United States Department of the Interior

February 23, 2024

Subject: U.S. Department of the Interior Comments – *Draft American River Common Features, 2016 Flood Risk Management Project, Sacramento, California, Supplemental Environmental Impact Statement/ Subsequent Environmental Impact Report XIV.*

Figure 7 related to
comment #55

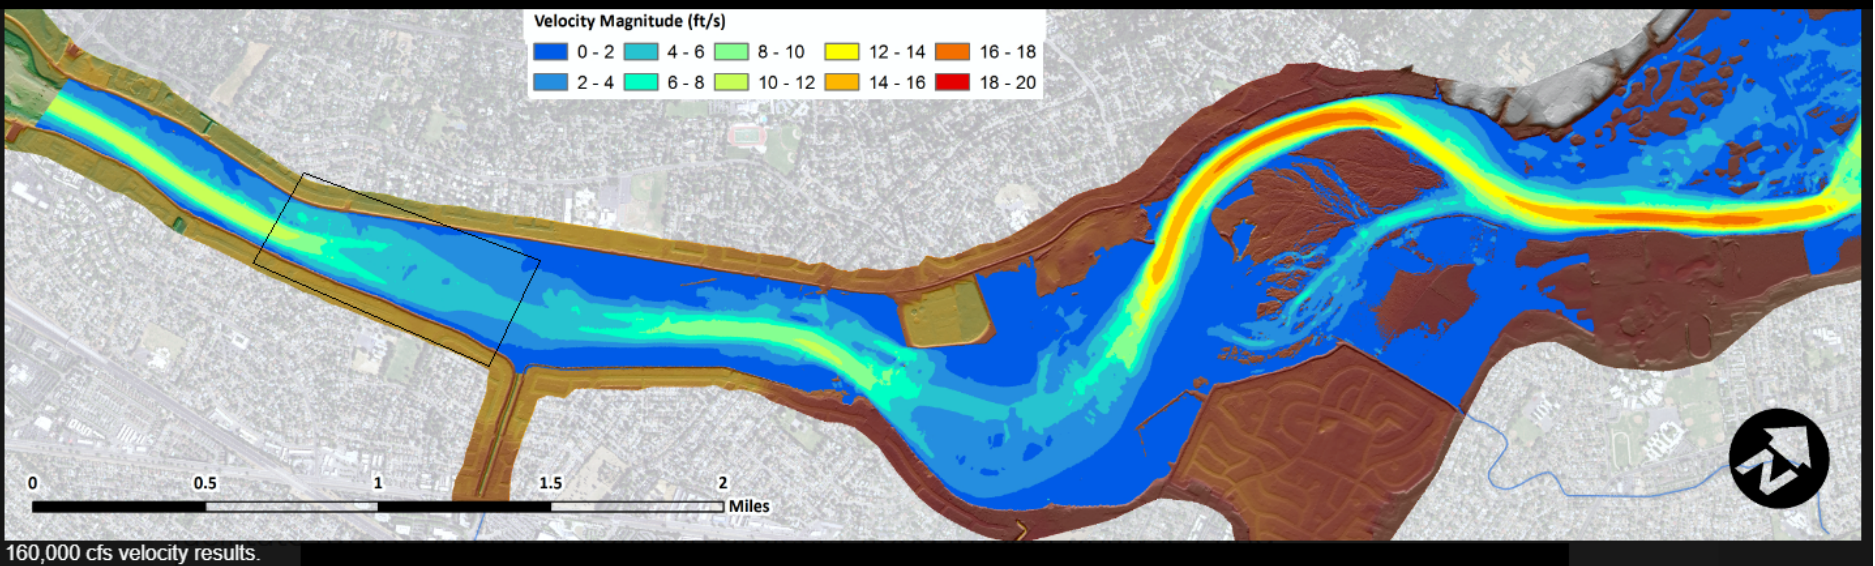
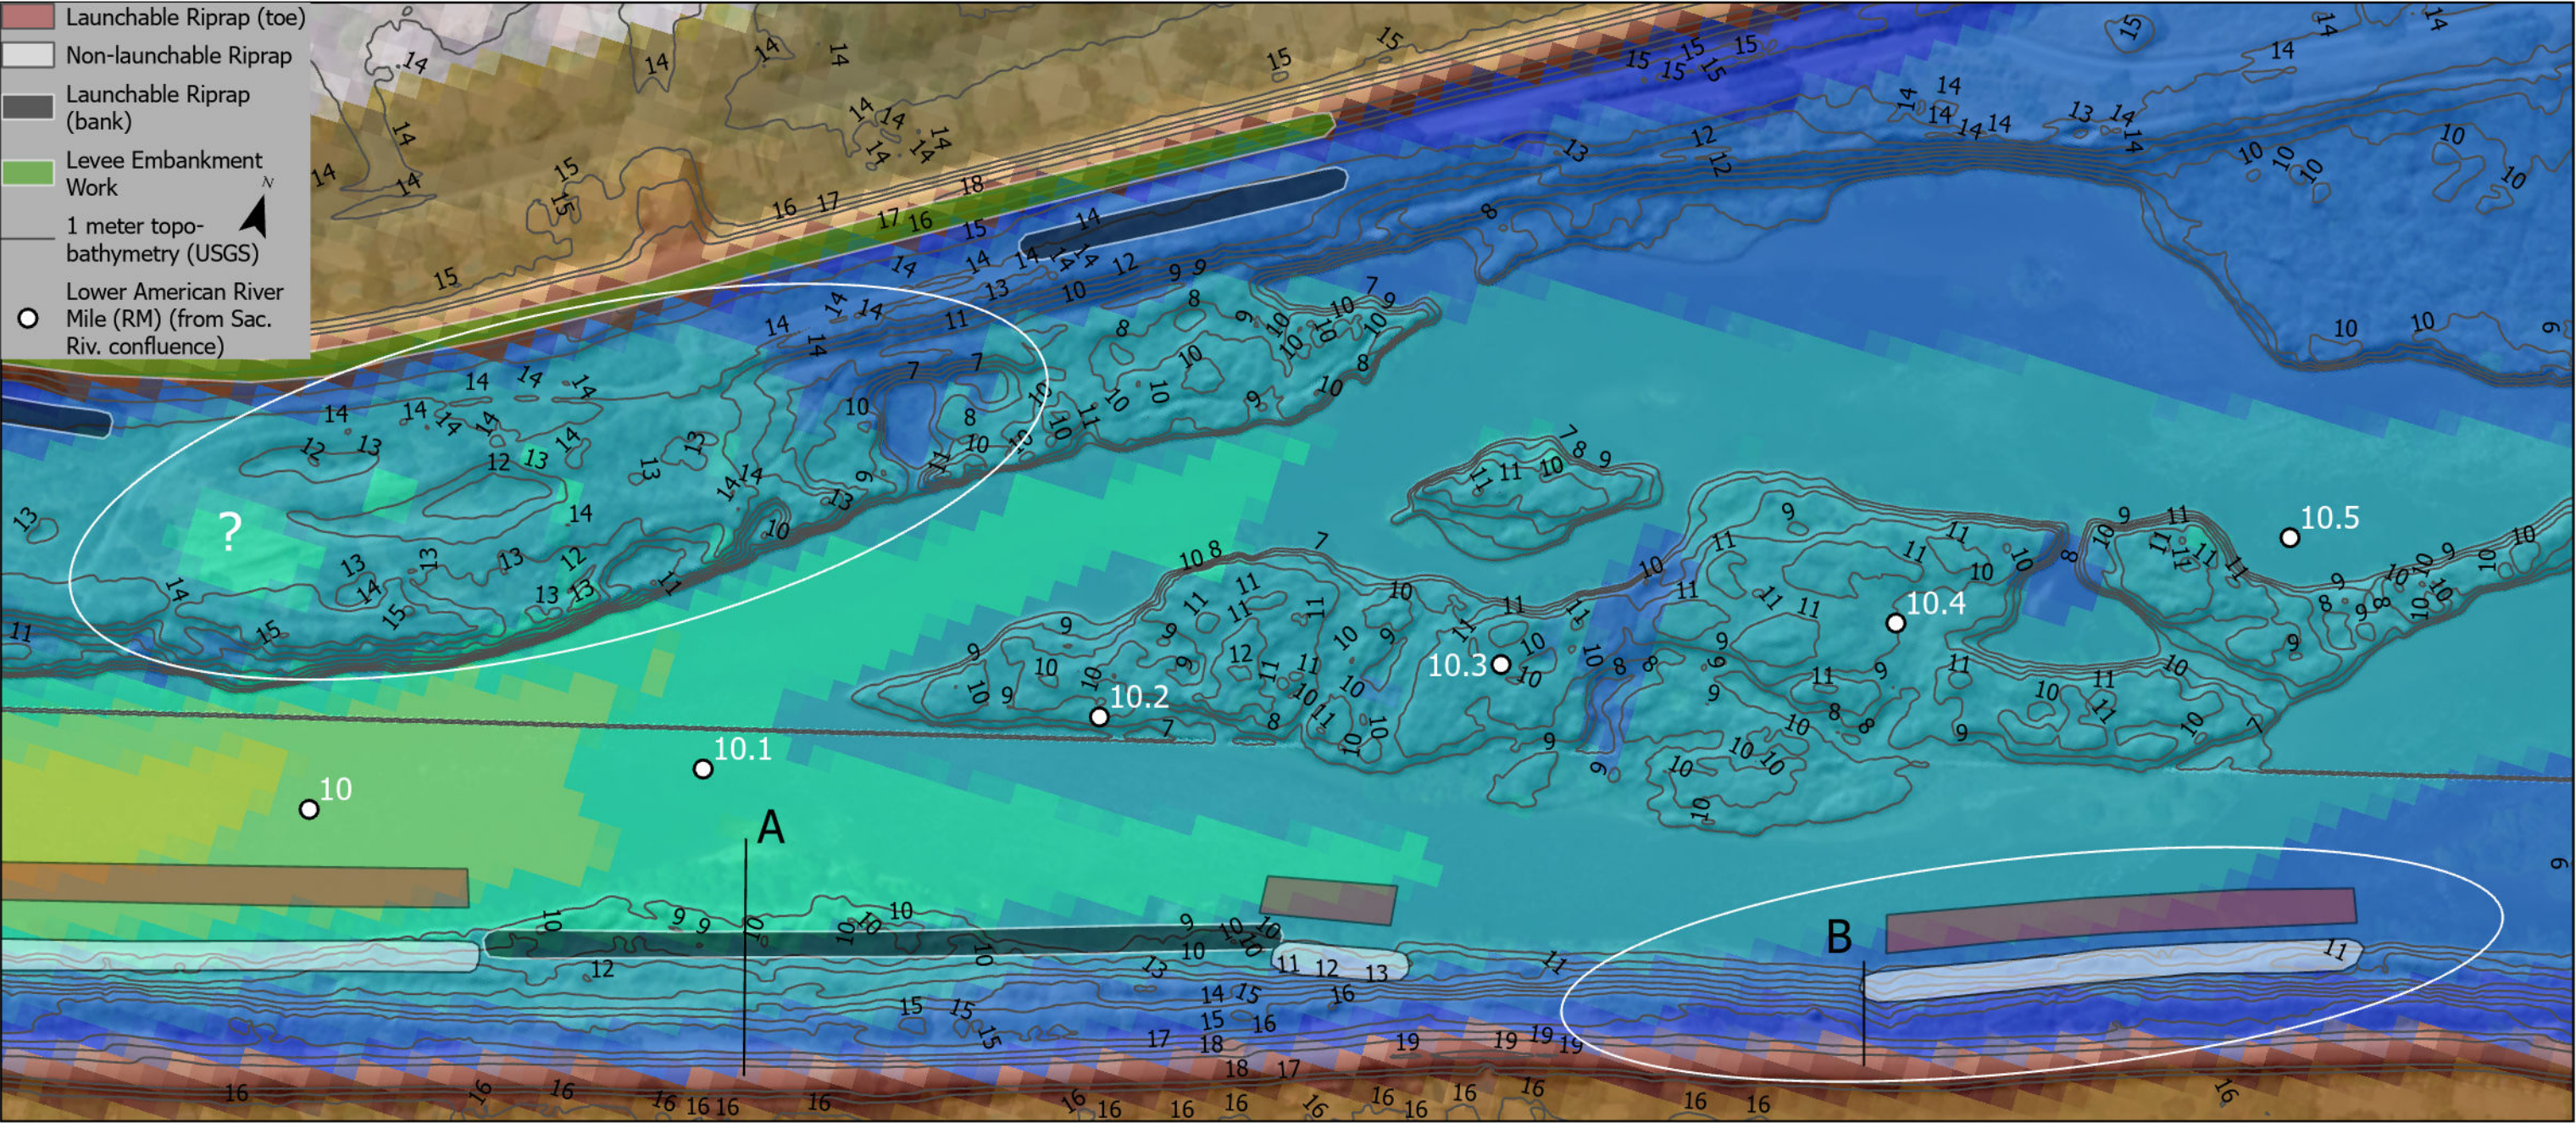
Similar to Figure 3, but zoomed in. This figure shows the original resolution of the depth-averaged 160 kcfs model velocity output found online (at right) and how it's more resolved than the 2004 model output when zoomed into some of the Project footprint (below). Note erosion control features are planned in very low-velocity "B" area and none are planned in the higher velocity "?" area where the channel thins.

Figure 8 related to comment 56 and 58

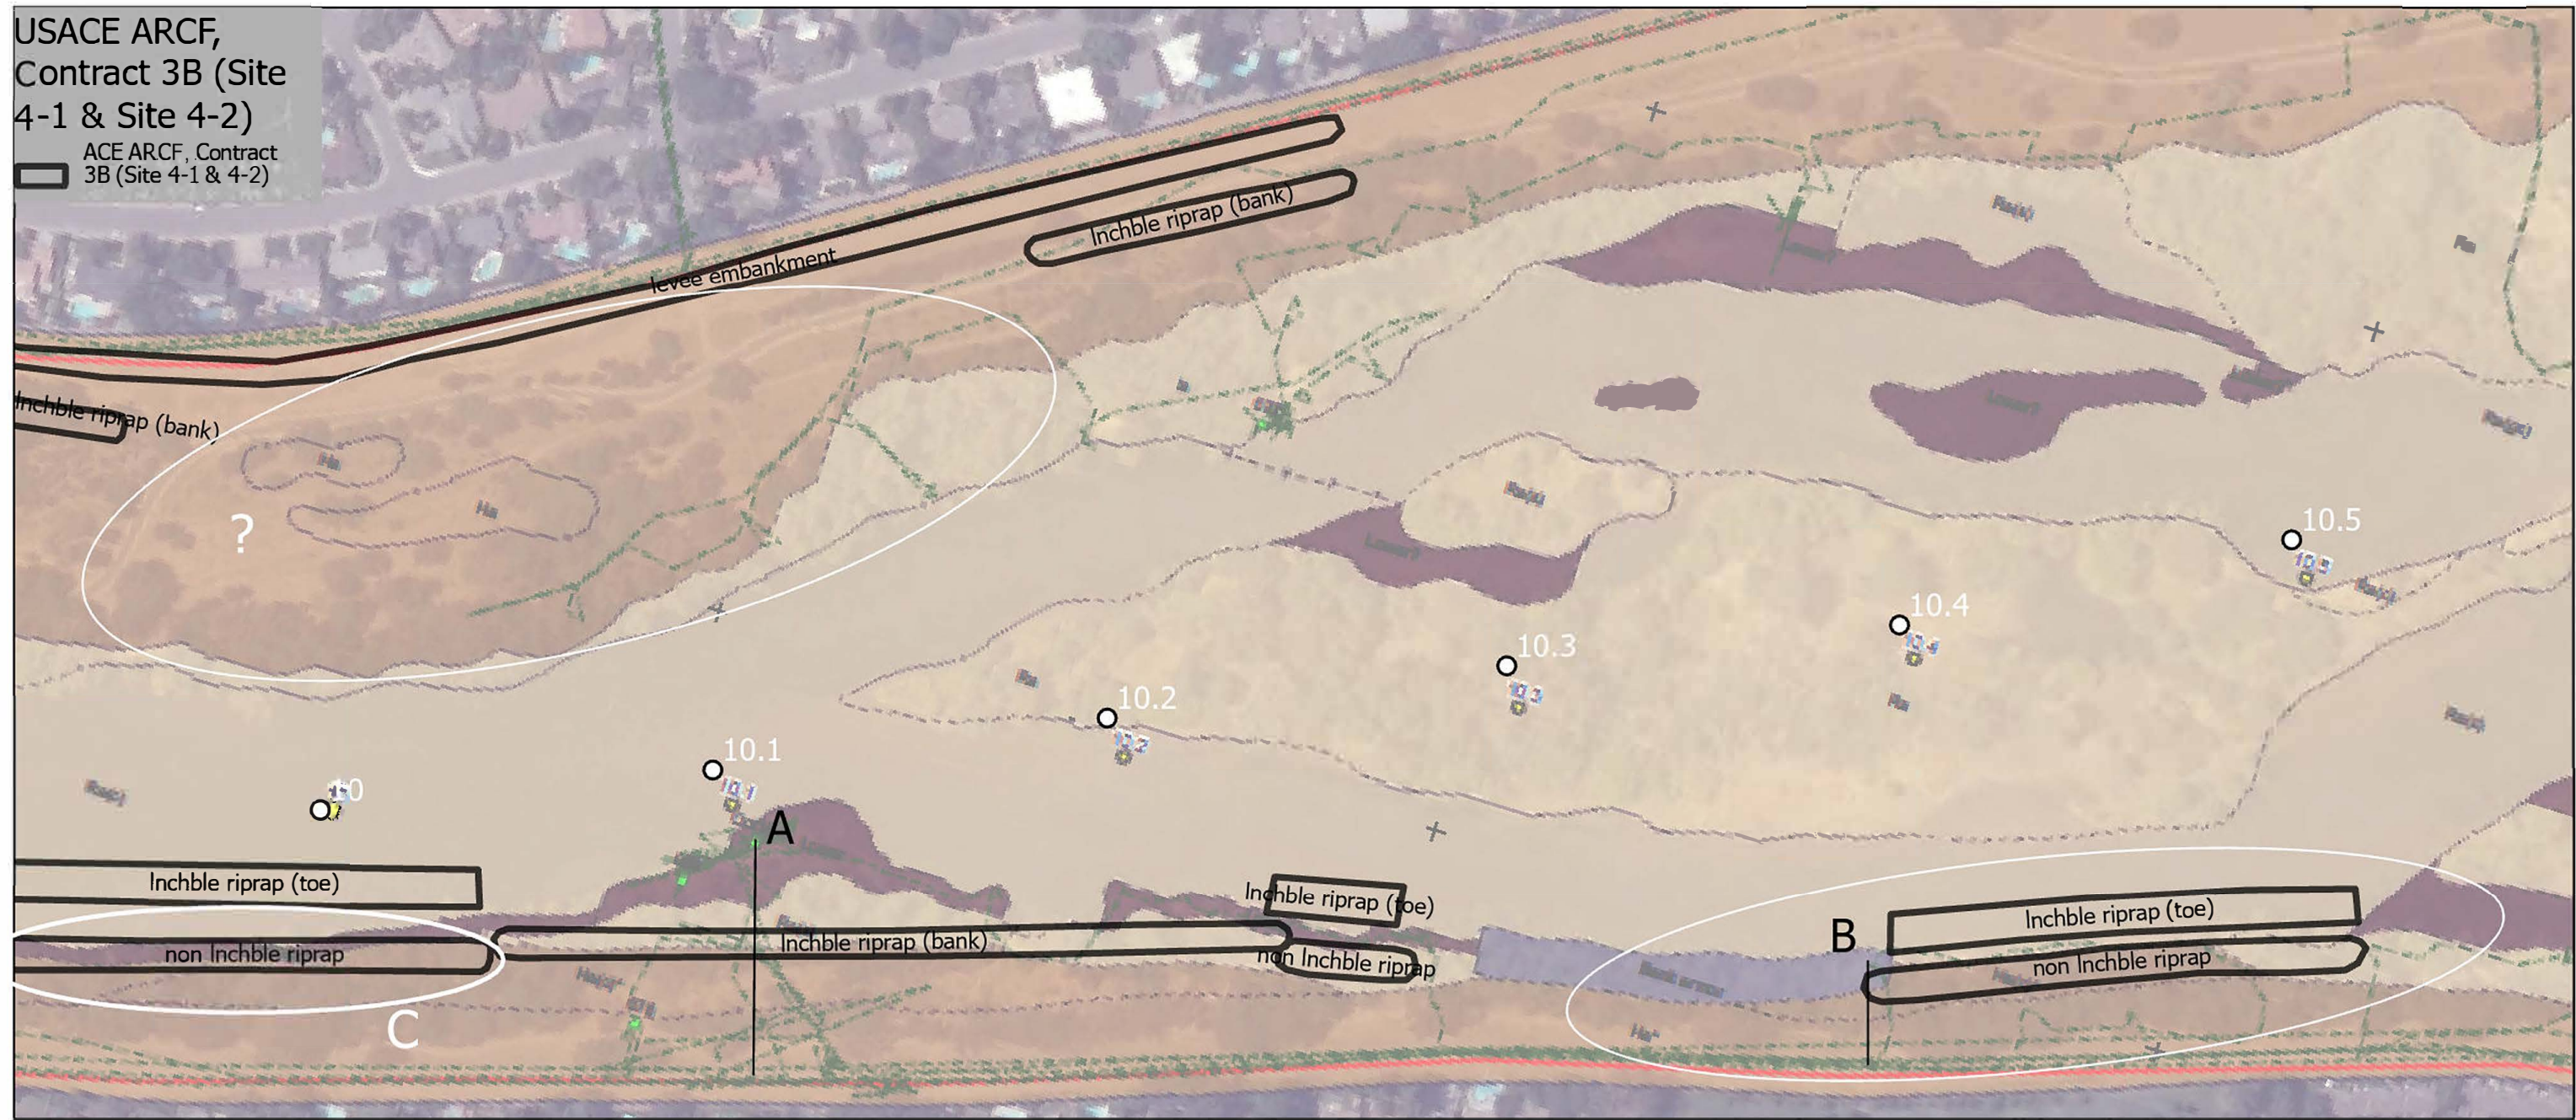
As shown in a picture above in via “Bank Armor” in Appendix A – Additional Report Figures, Figure 8, previous bank protection work has been conducted here by USACE. Without previous work shown, it’s difficult to analyze the project’s past performance and future goals. Why are locations where riprap has been installed previously not included visually in the DSEIR/SEIS’ figures?

Similar to Figure 4, this figure shows the intersection of Erosion Control Features with detailed geologic mapping conducted in 2012 (Fugro 2012). Note "Bank Armor" from previous USACE projects is depicted.

Figure 3.5.2-9. American River Erosion Contract 3B South Site 4-1 Details

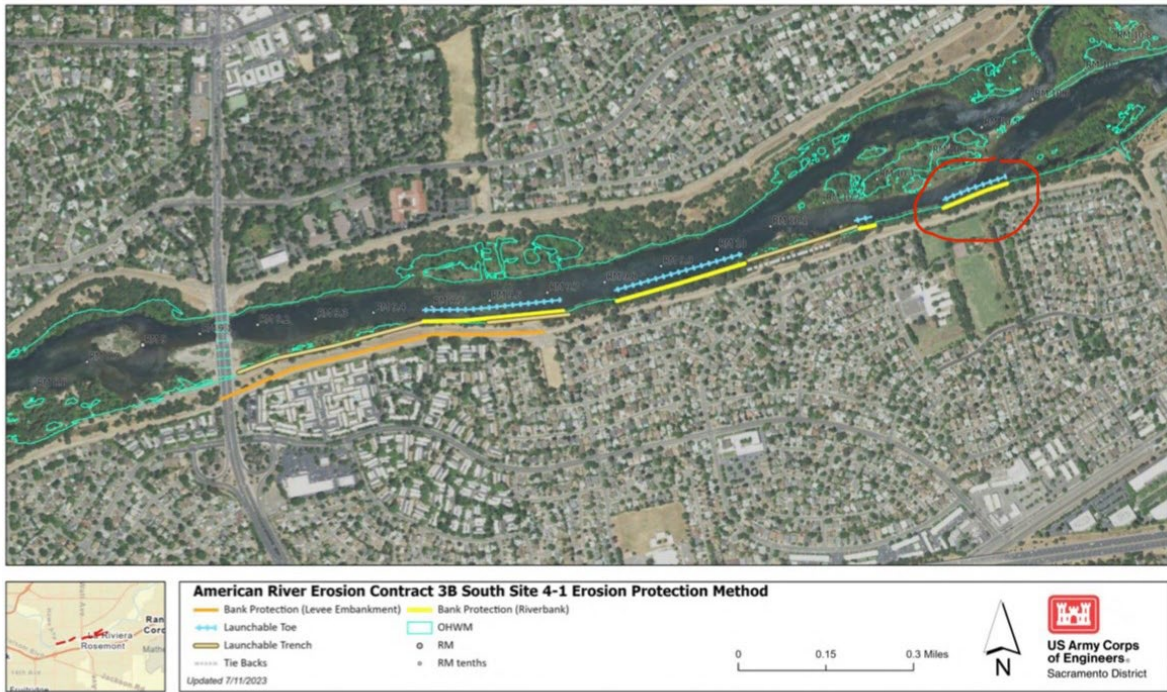
I urge the Army Corps to reconsider the work on the south side of the American river at this particular location. The entire American River Parkway is a beautiful scenic area that is heavily used by the public and by wildlife that would be severely degraded by the proposed work, much of which is totally unnecessary to protect the levees.

3 Attached is a screenshot of the area I am concerned about circled in red. If the work in this area could be modified such that the trees are not removed, and riprap is not placed along the shoreline making the water inaccessible, the project would be much more palatable. The proposed work will destroy habitat, ruin the scenic parkway, create hazards for tripping and attracting rattle snakes, and prevent access to the water for recreation.
